**COOK INLET HOUSING AUTHORITY
TYONEK TERRACES**
Anchorage, Alaska

*Kramer Electrical
Red Line Drawings*

NAME OR TYPE OF PROJECT
Tyonek Terrace
Electrical

TYPE & DATE OF PLANS
As-Built
September 15, 2003 34x26 26 Pages

4 LIGHTING PLAN - TYPICAL UNIT D
E2.5 SCALE: 1/4" = 1'-0"

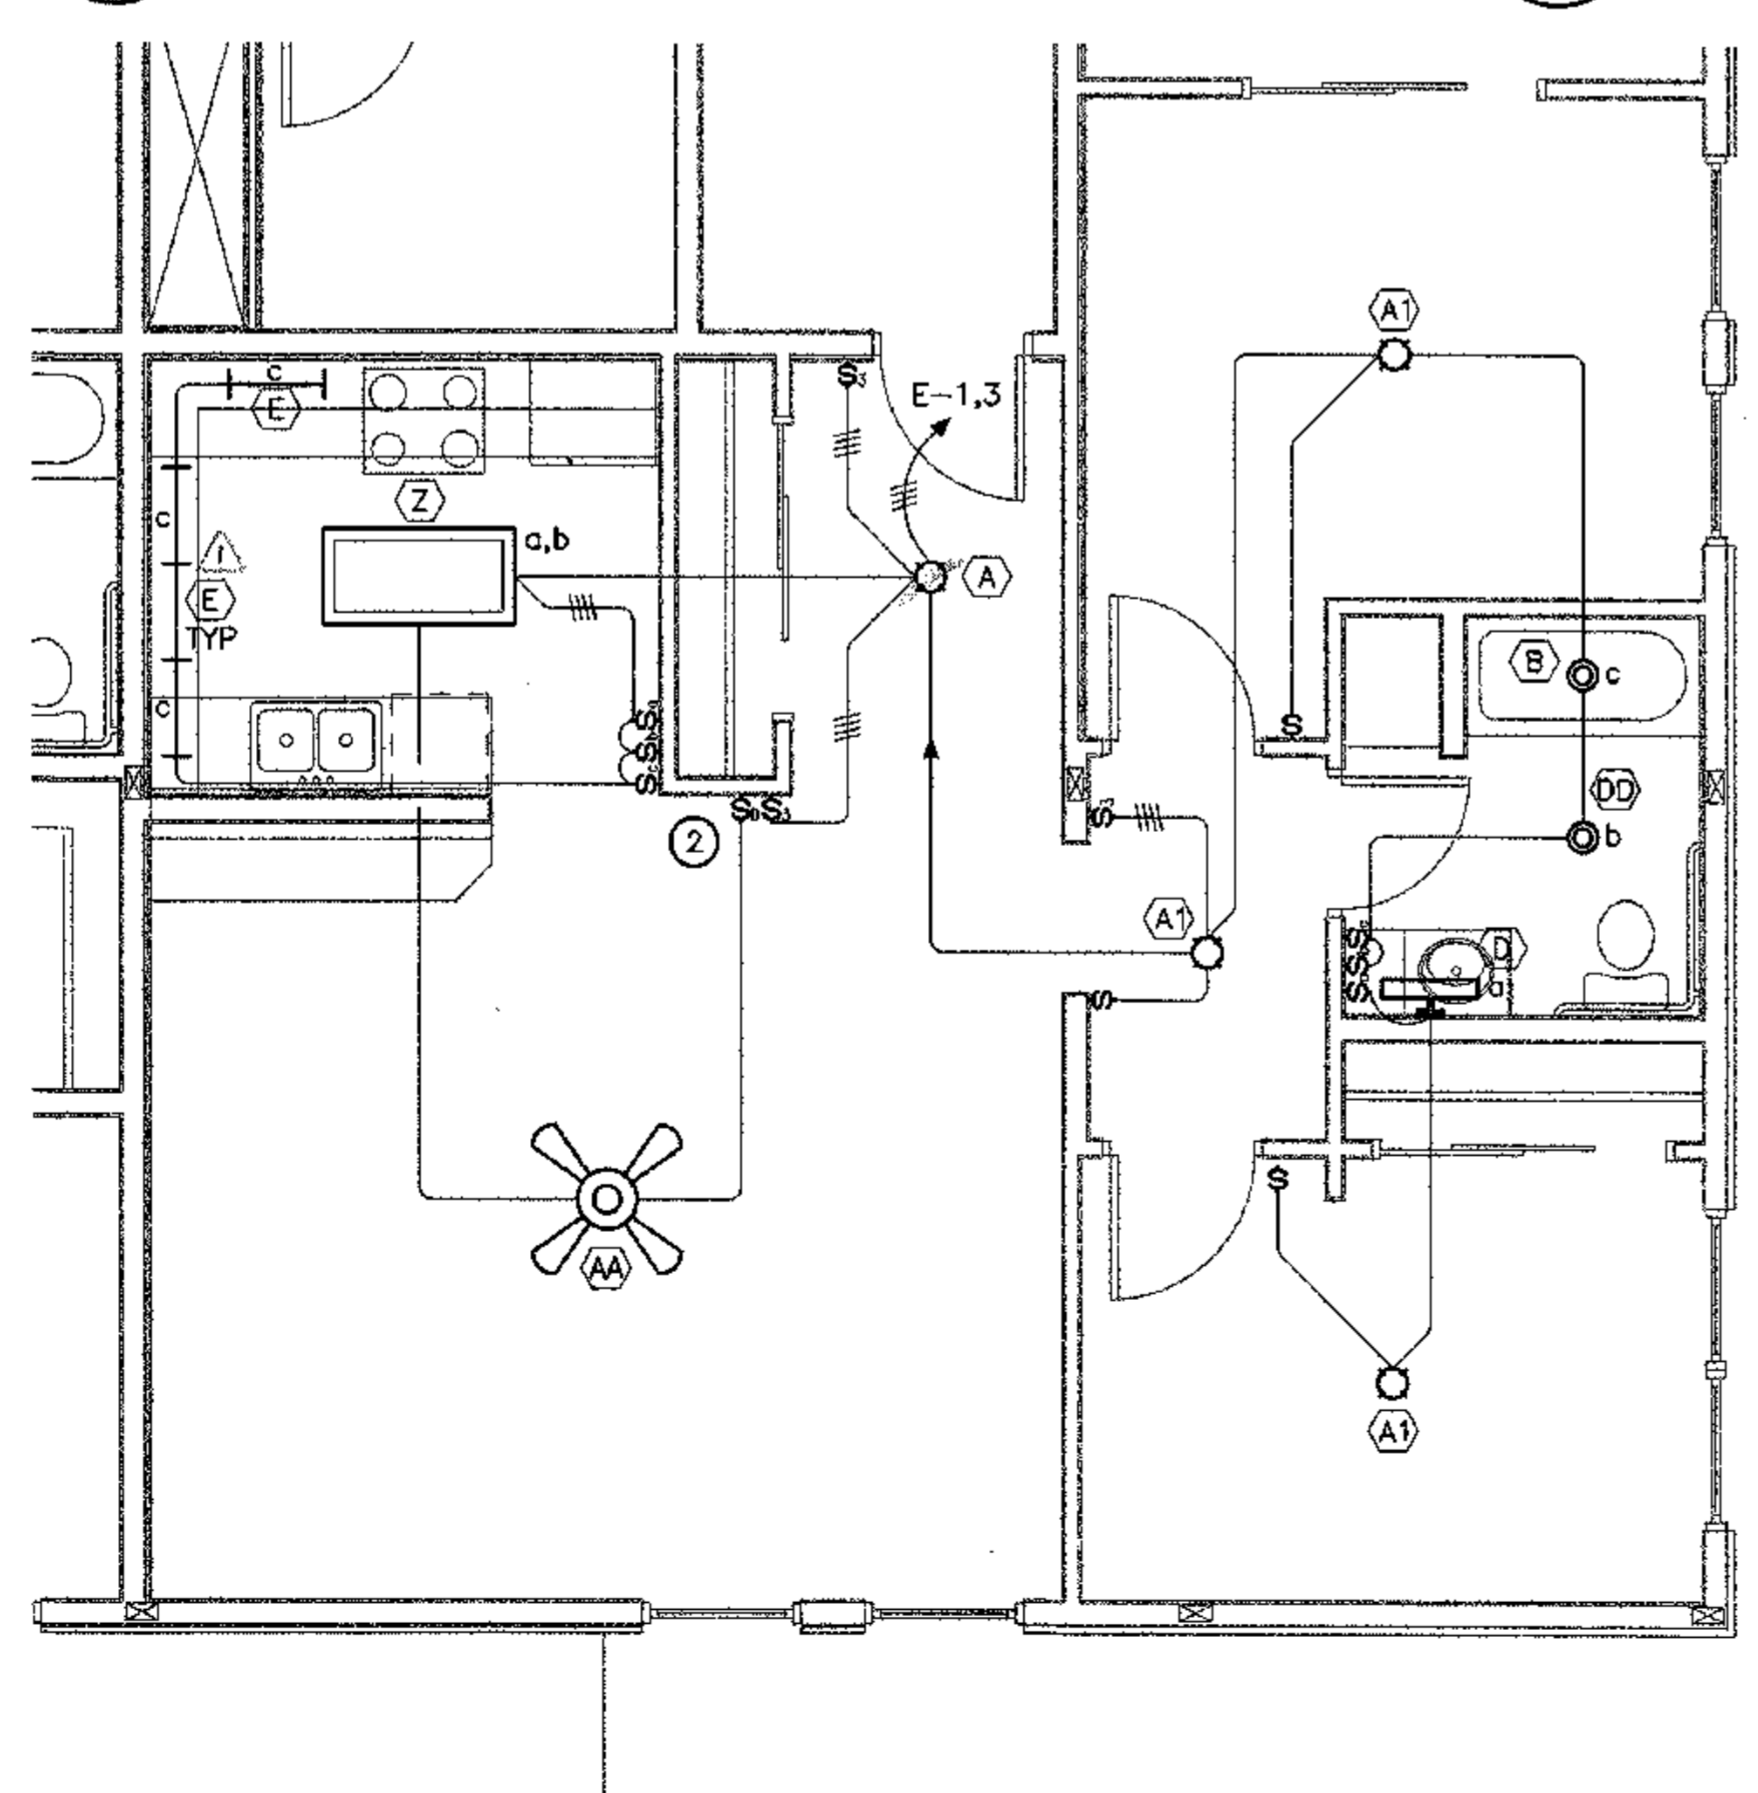
⚠ Under Cabinet Lighting Has Been Eliminated (Refer To REF # 22)

SHEET NO.
E2.6

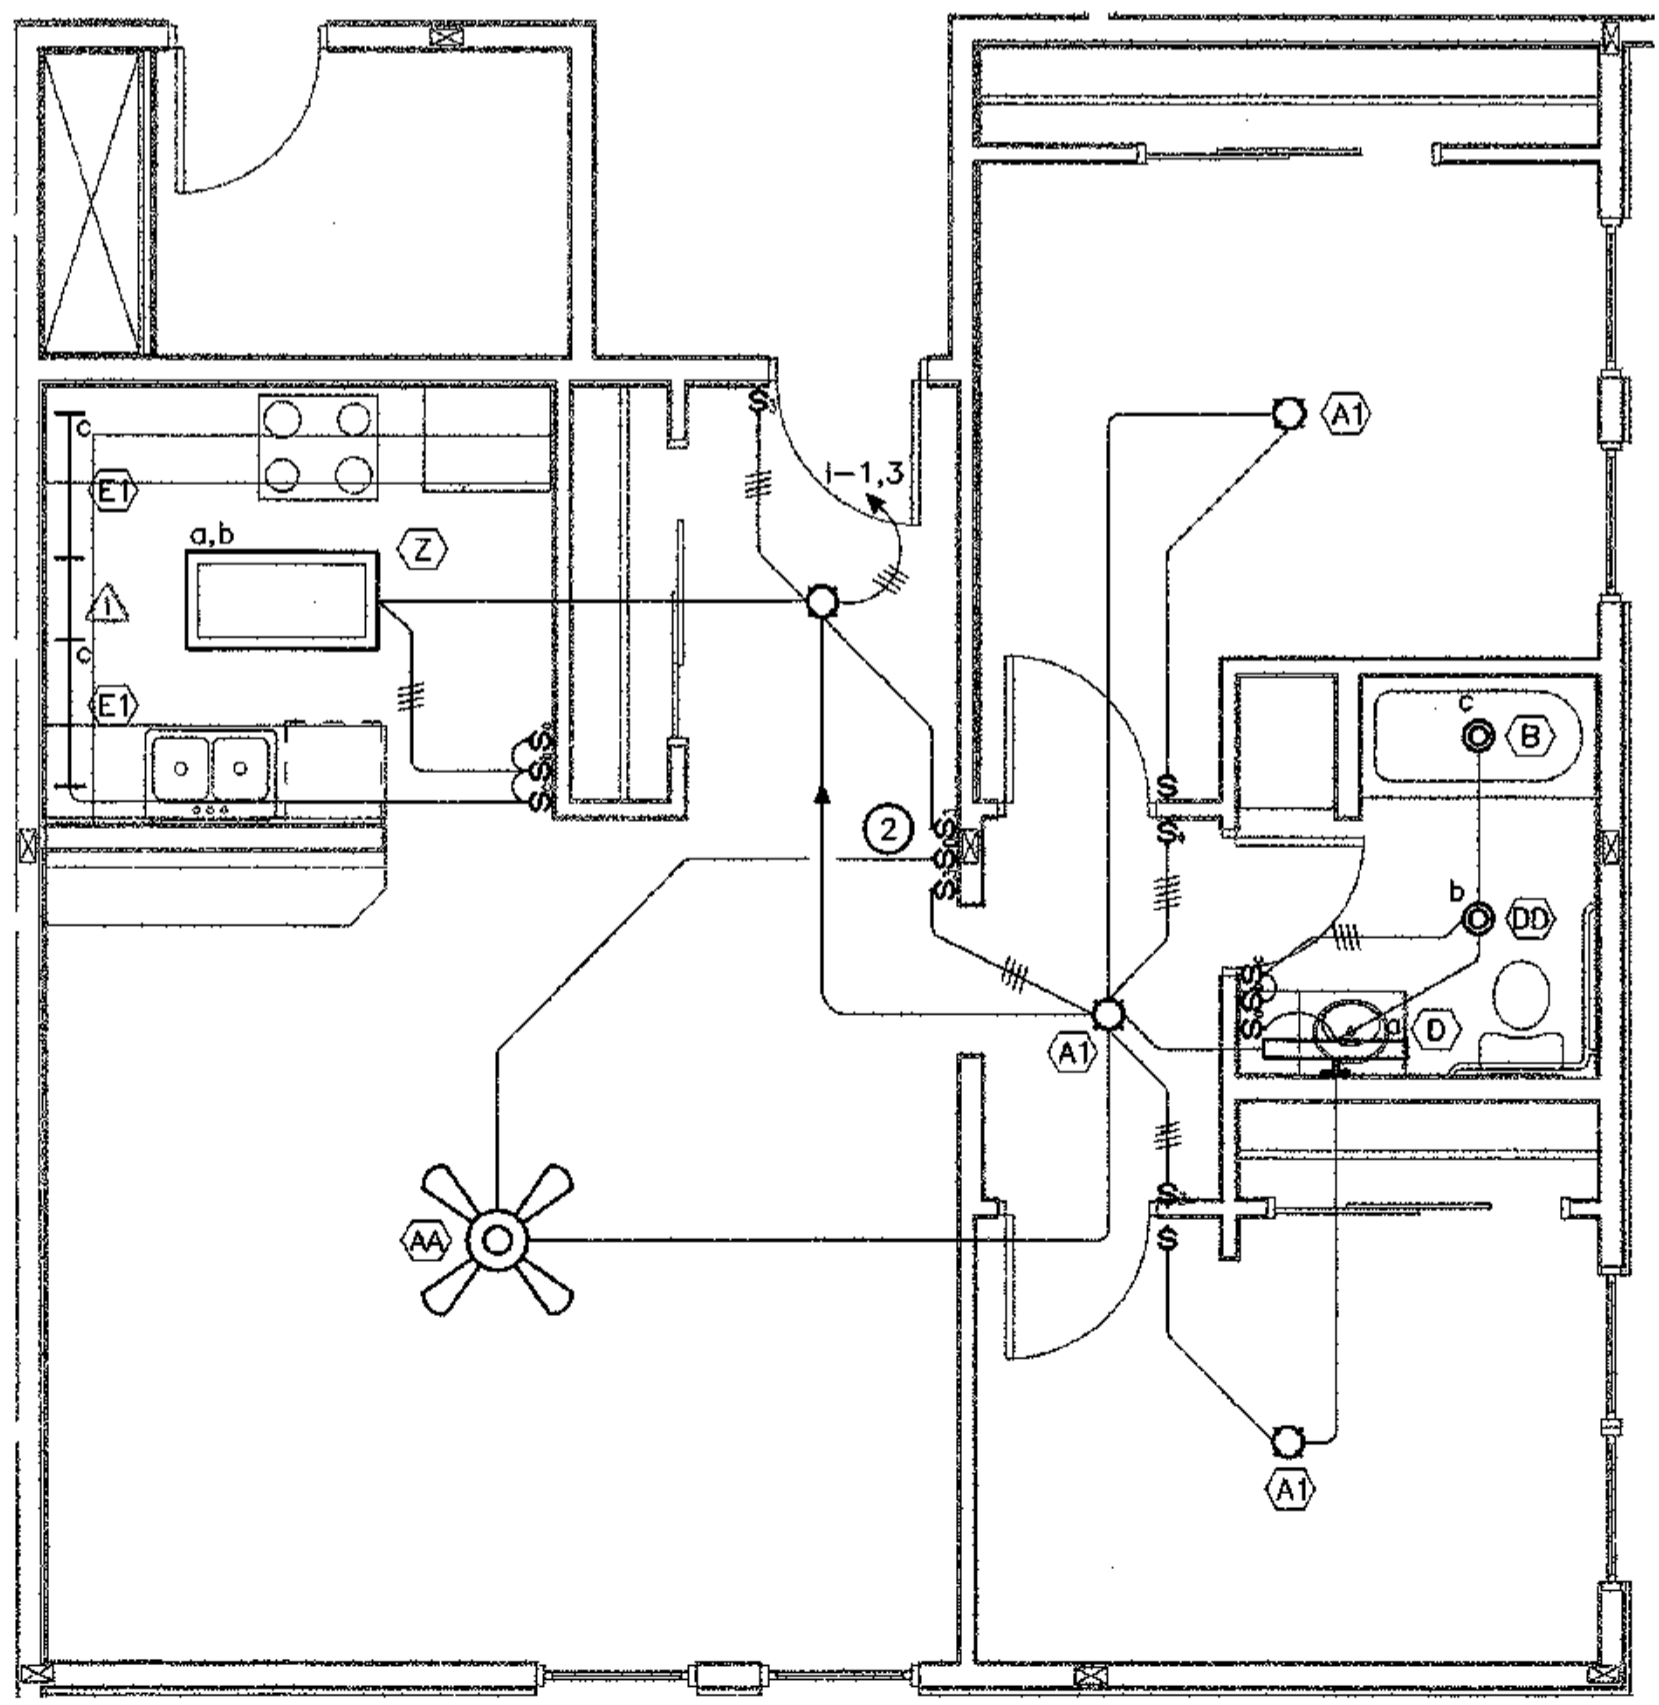
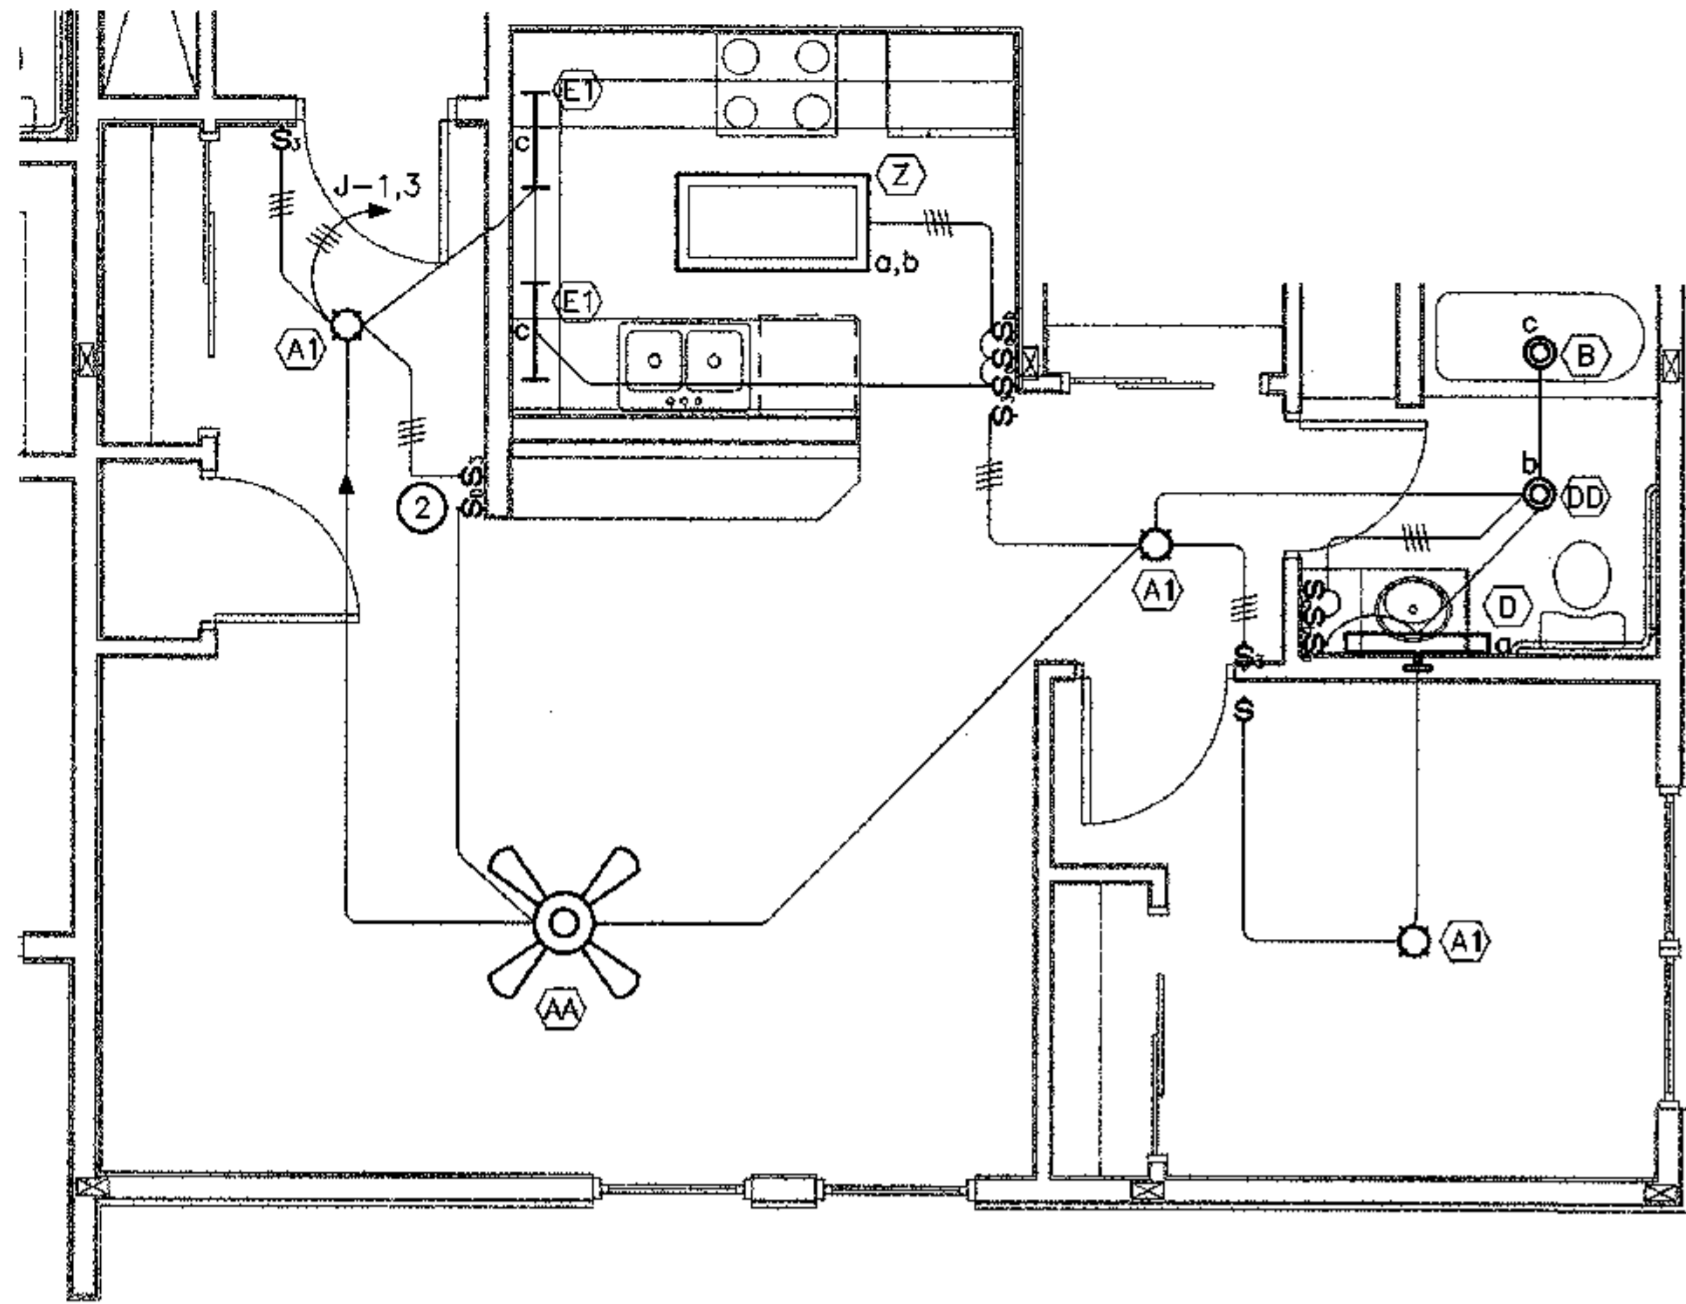
Ⓜ (Under Cabinet Lighting Has Been Eliminated. (Refer To RFI #28))
